STAFF REPORT

CITY OF COLUMBUS PLAN COMMISSION (July 8, 2015 Meeting)

Docket No. / Project Title: PUDF-16-04 (White River Dental)

AWS Properties LLC is requesting a modification to a Final PUD Plan for White River Dental. The request includes updates to signage and landscaping.

JOHNSON BLVD SIGN

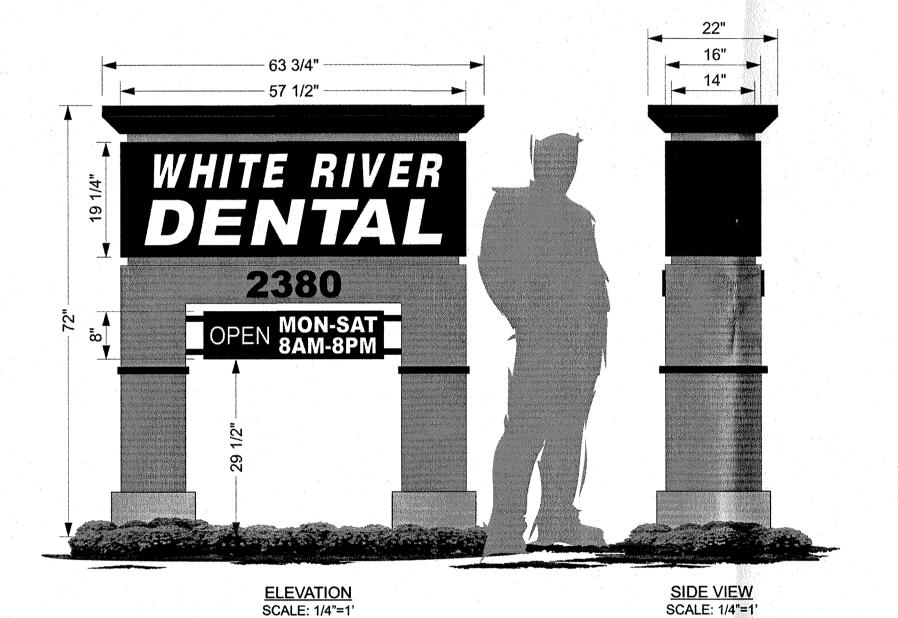
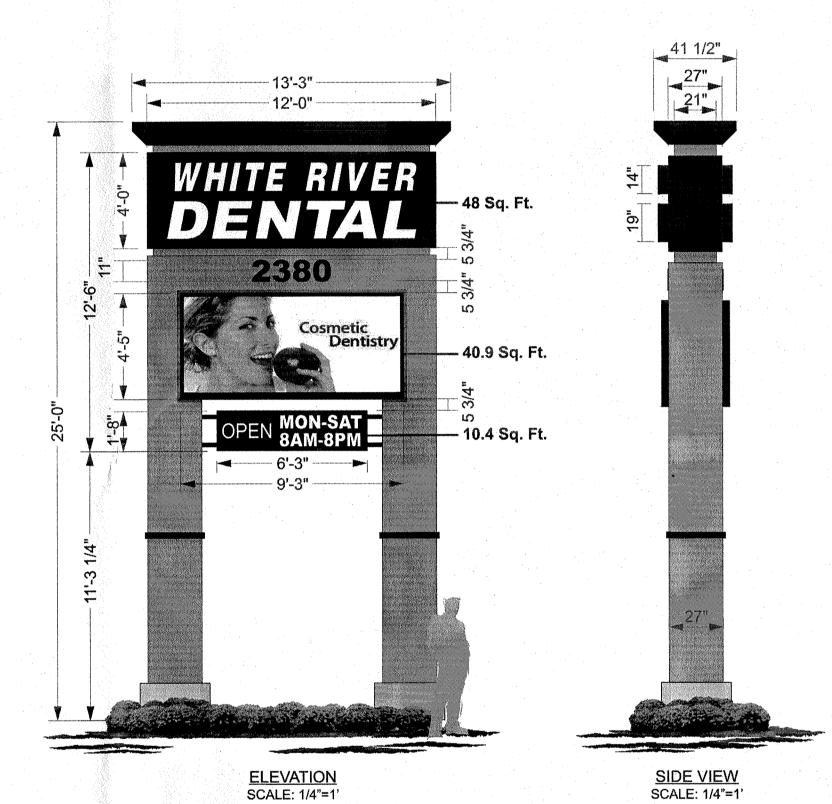
- 3. When comparing the landscaping to the CR (Commercial: Reginal) zoning district requirements, the landscaping under the signs does not comply. The larger sign (25 foot tall) requires landscaping at the base of the sign. Section 8.1(5) of the Zoning Ordinance states that signs over 6 feet need landscaping at the base of the sign. The 40 points required is approximately 6 shrubs within 5 feet from the base of the sign. It is important to note that, under the CR requirements, the shrubs required for the sign cannot double count toward any other landscape area. The current plan has perennials under the 25 foot sign. Even though it is not required, the smaller sign does have 6 shrubs below it. The Plan Commission does have the discretion to require these shrubs below the signs.

- 1. Landscaping (6 shrubs) shall be required at the base of the 25 foot sign.
- 2. The north side of the property shall have landscaping. The trees along the pond are to be retained, or some landscaping shall be moved to the north side of the building from other landscape areas that have a large amount of landscaping.

Drawing Name:
PHASE 2
LANDSCAPE PLAN
Drawing Number:

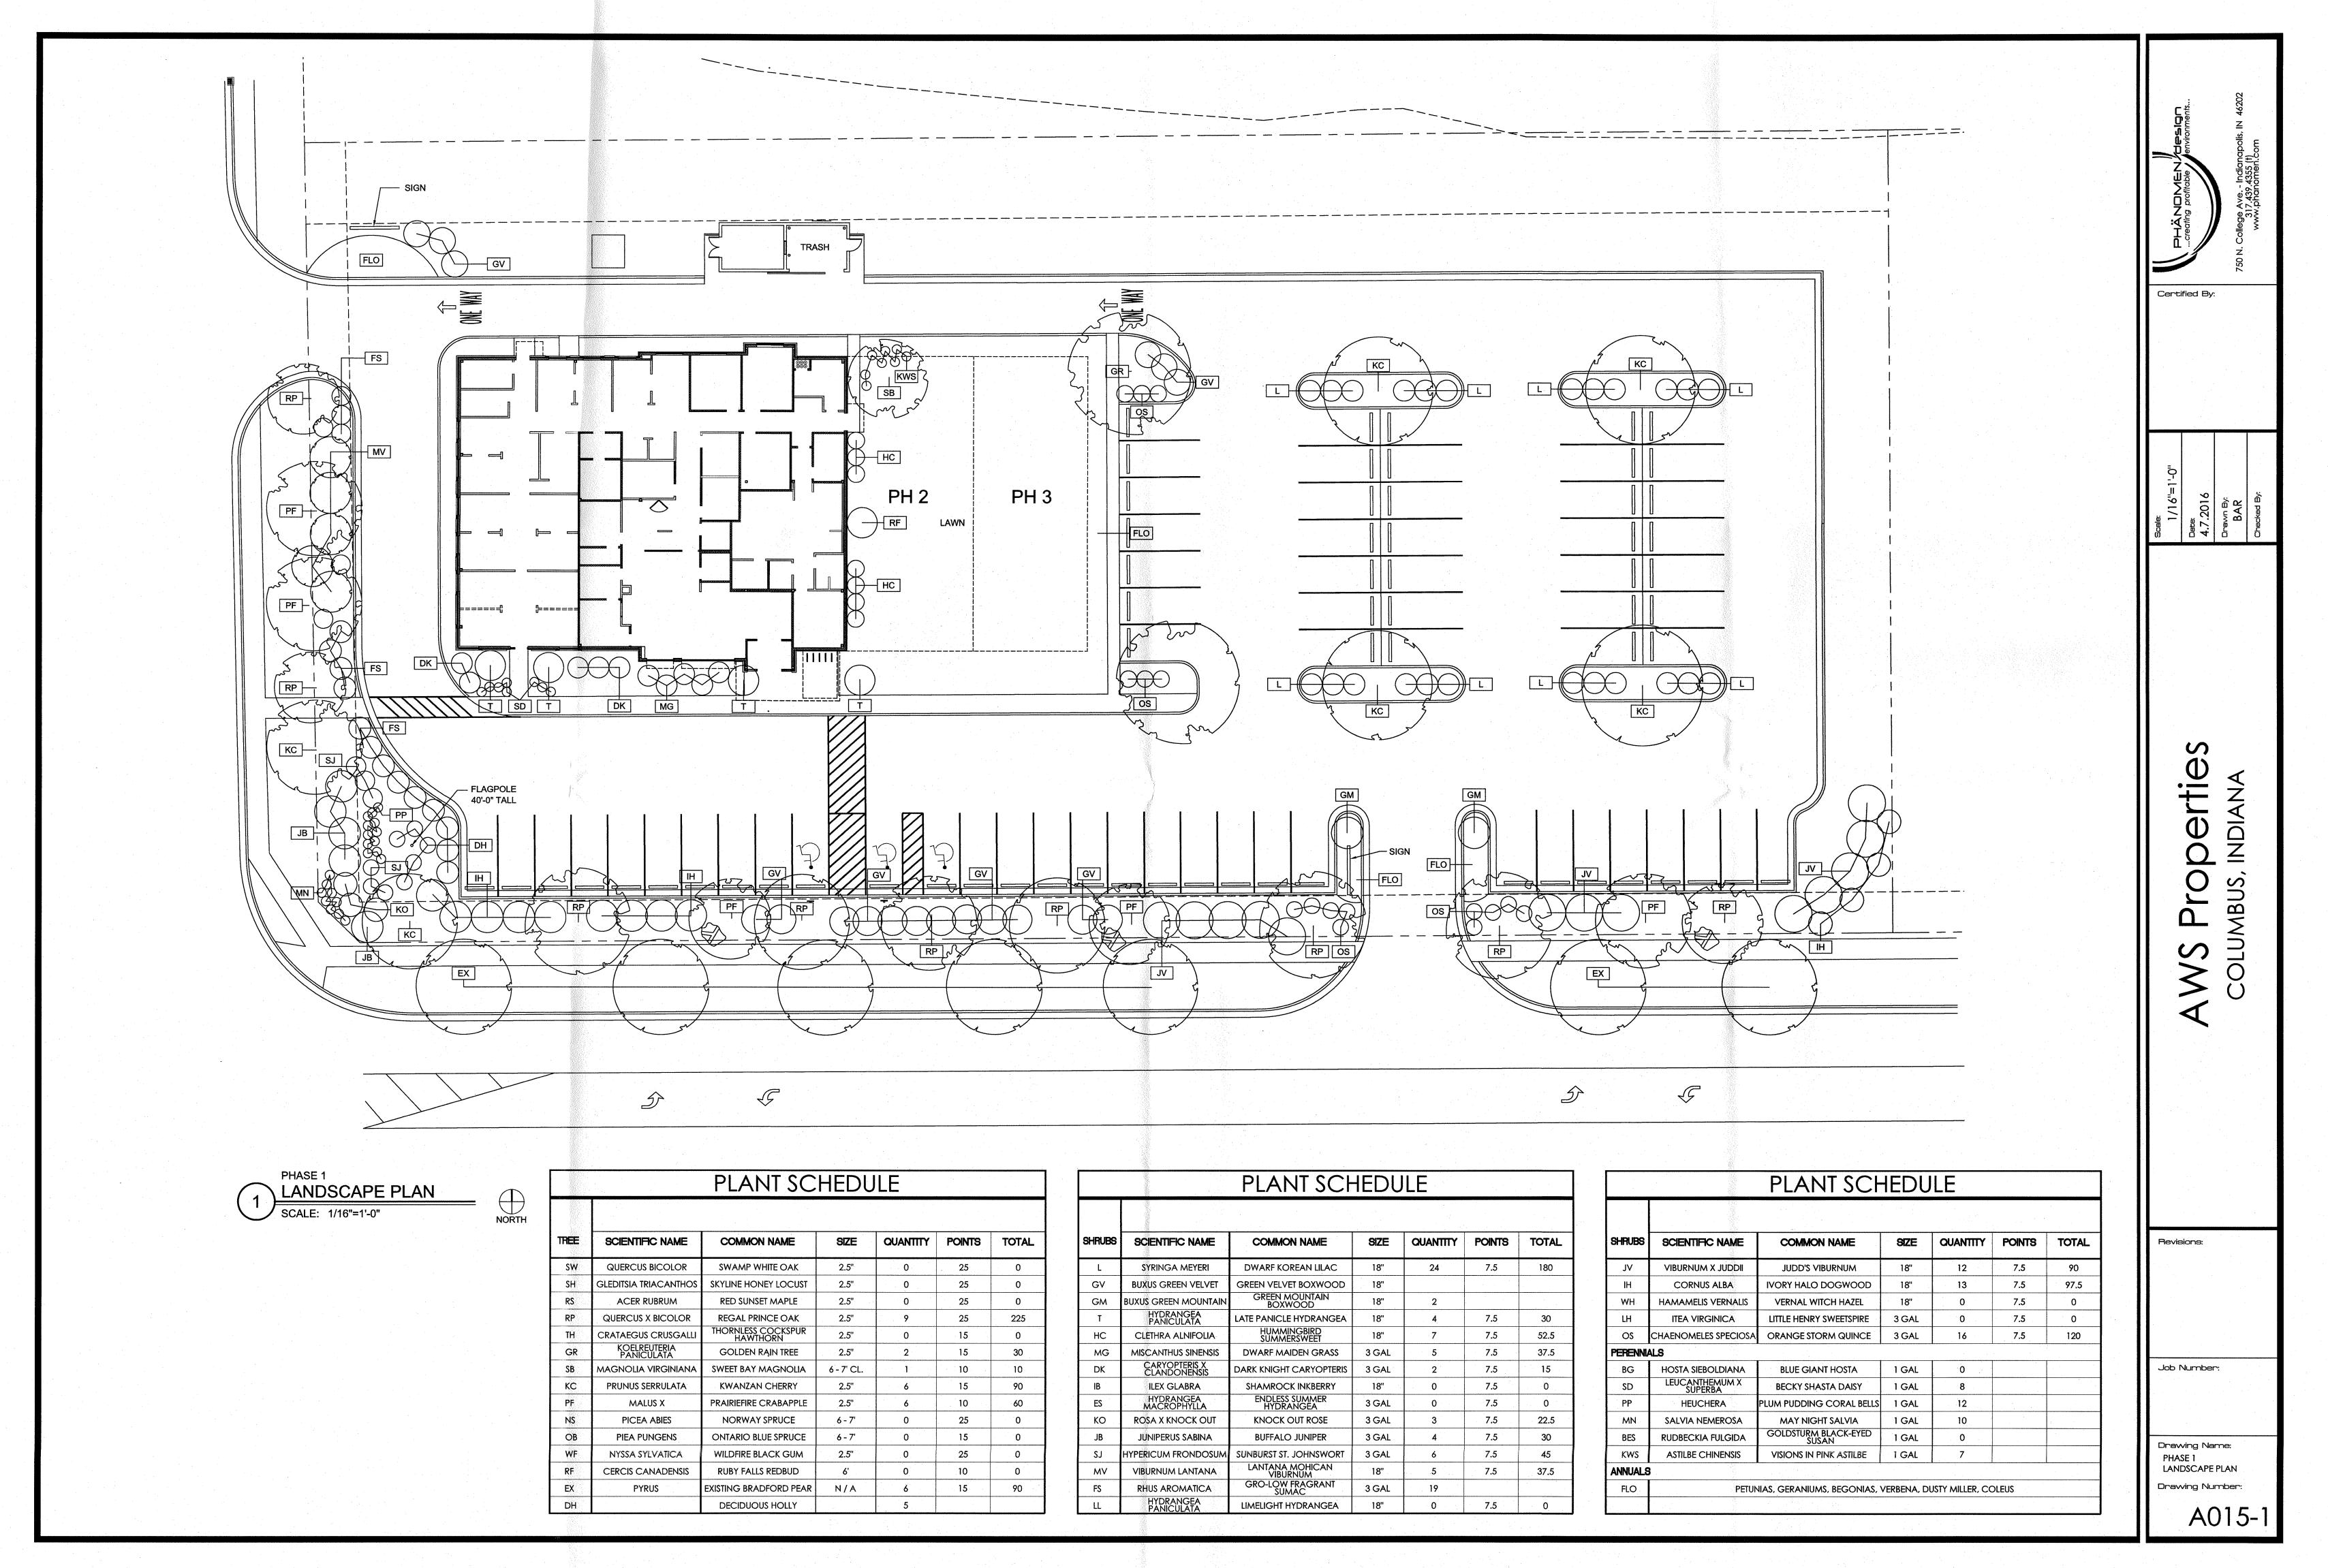
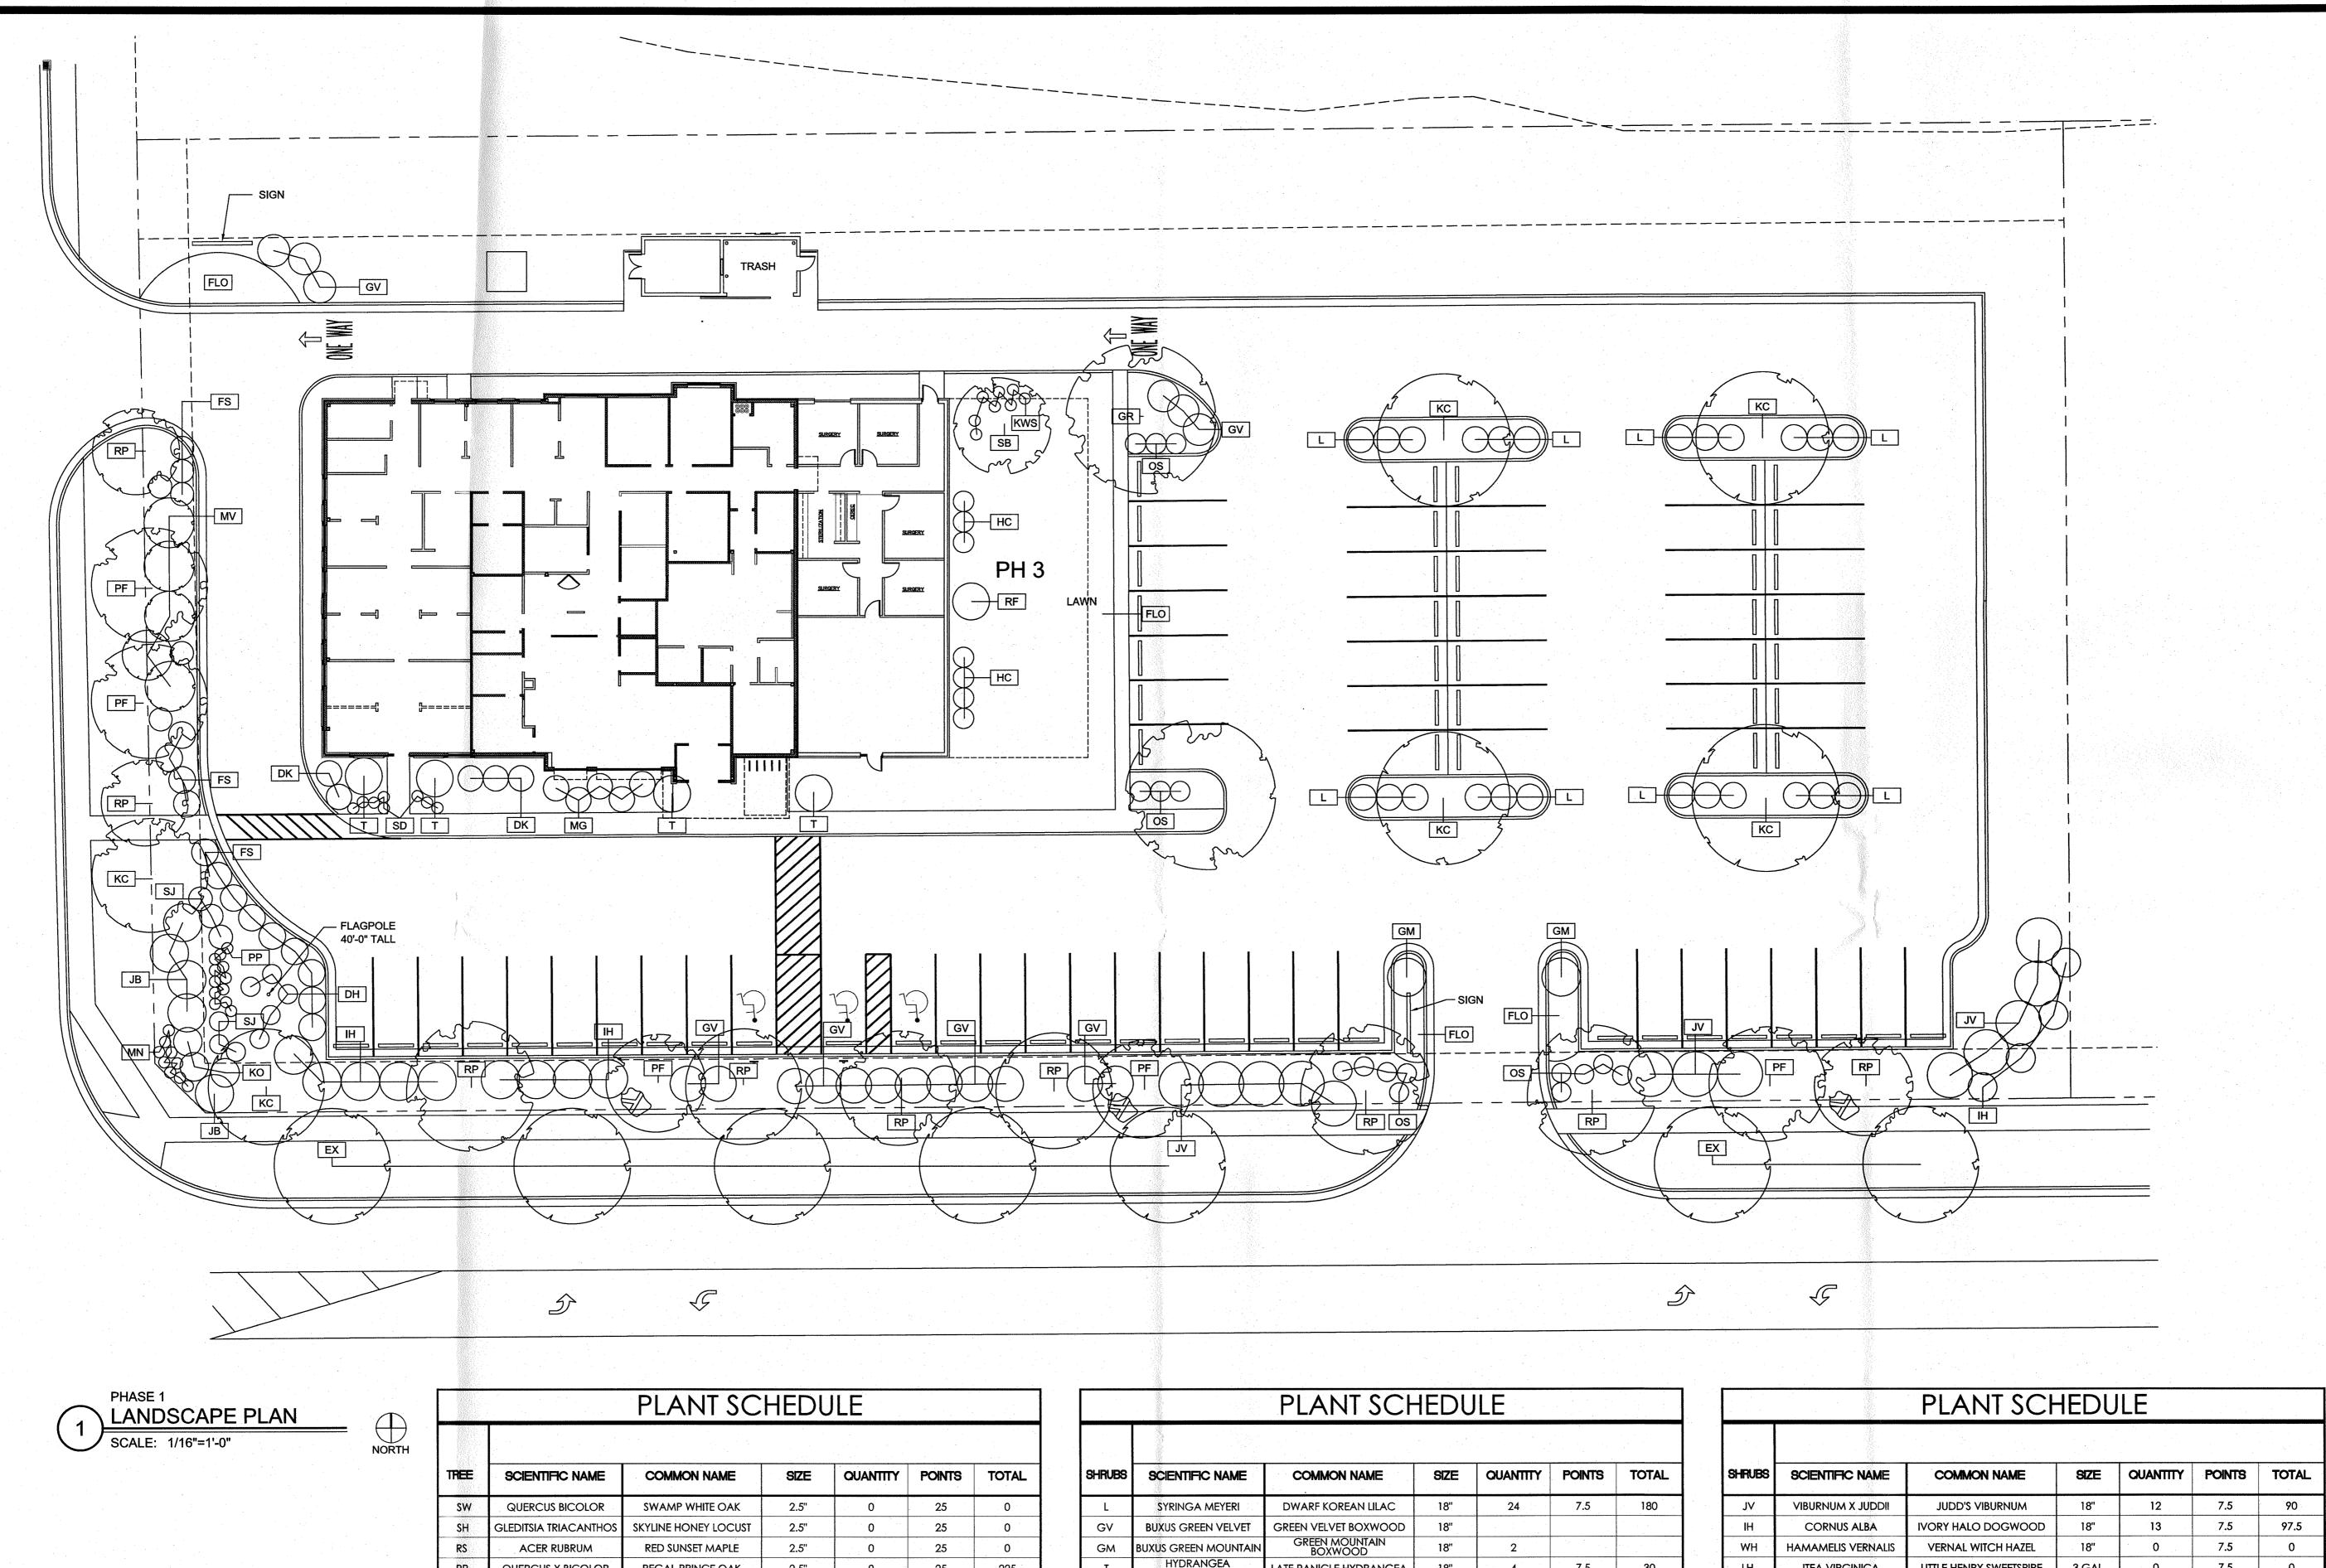
- 4. When comparing this request to the CR (Commercial: Reginal) zoning district requirements, the applicant has provided enough over-all points for the landscaping requirements. The landscaping, however, is not in the appropriate detailed areas as designated by the Zoning Ordinance. The lot interior, and front setback areas have plenty of "landscape points", while the, parking lot frontage, parking lot interior, and signage landscaping do not meet the requirements. The parking lot frontage is deficient one shrub, but the plan has more trees than required. The parking lot interior has enough plants, but the square footage of the planting area is technically too small. The Plan Commission does have the discretion to approve or deny the landscaping plan.

- 5. The previous landscaping plan showed 12 shrubs along the northern foundation of the building. There were also 9 trees and 15 shrubs along the northern portion of the property. These plants helped screen the trash enclosure and parking areas from view from those traveling south along Johnson Boulevard. The proposed landscaping plan does not have any landscaping on the northern portion of the property. The preliminary PUD states that for all buildings on the north side of Merchants Mile, landscaping and architectural treatment shall be along both north and south sides of buildings. The intent behind this is to not have a "back" of the building. It is important to note that there are trees surround the retention pond to the north of the subject property. These trees provide a screening for the northern portion of the building to those traveling south along Johnson Boulevard. It would be beneficial to either retain these trees along the pond, or provide plants along the northern portion of the property. When adding new plants

along the north side of the building, the applicant can move plants from other areas around the site that "exceed" the requirements. For example, there are plants along the parking lot frontage that exceed the requirements for the CR (Commercial: Regional) zoning district. Some plants from this area could move to the north side of the property.
